## Impact of 40 % UIF on OID/SSJID's Diversions

August 22, 2018 – Item 4
By: Tim O'Laughlin
Attorney for San Joaquin Tributaries Authority

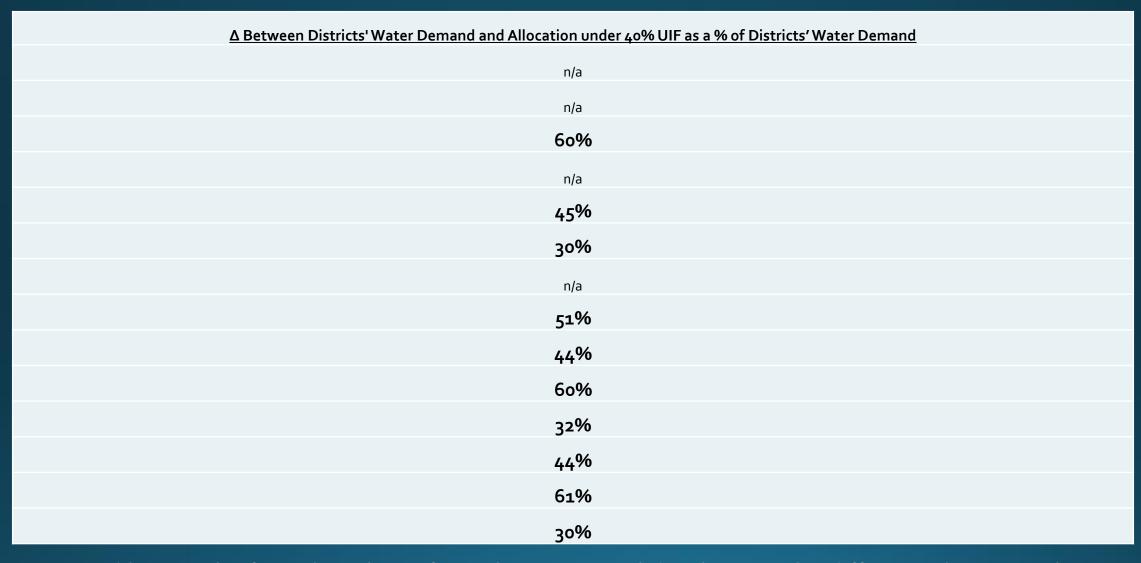
Pictured here are modeling results showing the impact of the Board's preferred alternative, 40% UIF from February – June, for the years 1922 – 1935 on the Districts' diversions. The far right column shows the difference between the amount the Districts would have been shorted by the 40% UIF requirement as a percentage of the Districts' total entitlement for that year.
